UNITED STATES
NUCLEAR REGULATORY COMMISSION
REGION V
1990 N. CALIFORNIA BOULEVARD
SUITE 202, WALNUT CREEK PLAZA
WALNUT CREEK, CALIFORNIA 94596

IE Bulletin No. 80-20

FAILURES OF WESTINGHOUSE TYPE W-2 SPRING RETURN TO NEUTRAL CONTROL SWITCHES

FIGURE 1

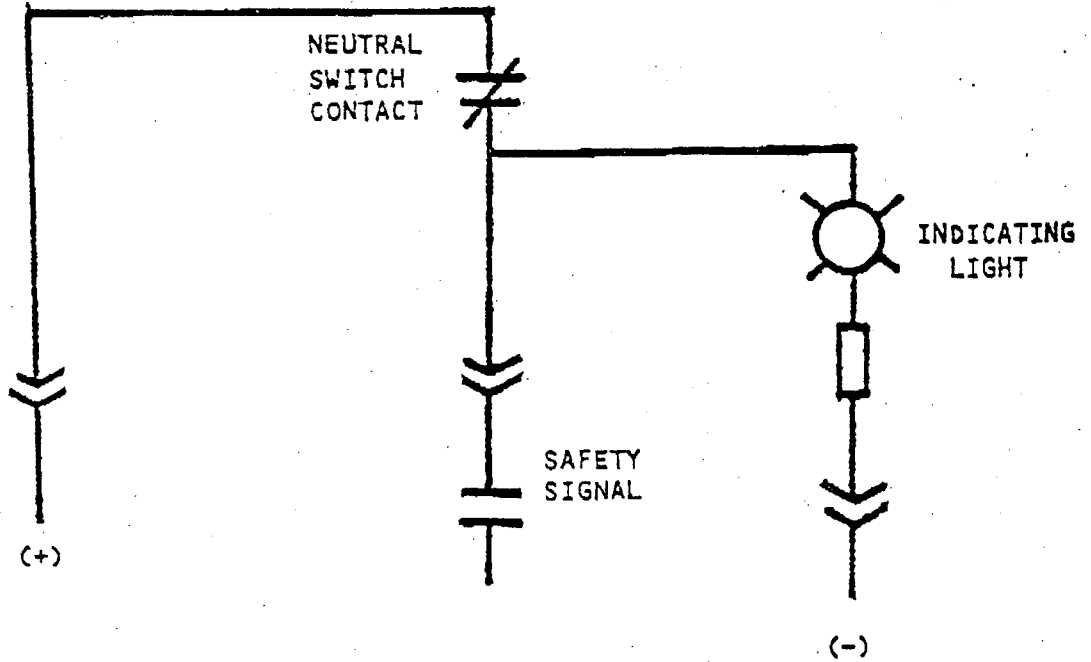
A review of this matter by Westinghouse led to the issuance of NSD Technical Bulletin No. NSD-TB-80-9 to the utility owners of all Westinghouse operating plants. The recommendations contained in the Westinghouse technical bulletin include: (i) testing the neutral position contacts of the subject W-2 switches for continuity, and (ii) rewiring of the indicating light circuit to permit the early detection of a neutral contact failure as shown in Figure 1.

Depending on how the indicating light circuit is wired, loss of continuity thru the neutral position contact of a W-2 switch could remain undetected until the equipment associated with the switch were called upon to operate. Since such a failure would be equivalent to by-passing the system associated with the switch, consideration should be given to rewiring the switches used in safety-related applications as shown in Figure 1. Such rewiring would provide an acceptable means for detecting contact failure, provided the indicating light is in the control room and readily visible by the operator. If the indicating light is not so located, consideration should be given to annunciating the neutral position contact failures at the control room to alert the operator of the inoperable status of a safety-related system. In addition, consideration should be given to adding redundant contacts to the W-2 switches or to replacing the W-2 switches with others having a more positive contact wiping action.

3. Licensees of operating plants and holders of construction permits shall describe the longer term corrective measures planned and the date by which such measures will be implemented by actual installation or by design change, as appropriate. As a minimum, the longer term corrective measures should include rewiring the indicating light as shown in Figure 1 provided the light is readily visible to the control room operator. If not, failures of the neutral position contacts should be annunciated in the control room.
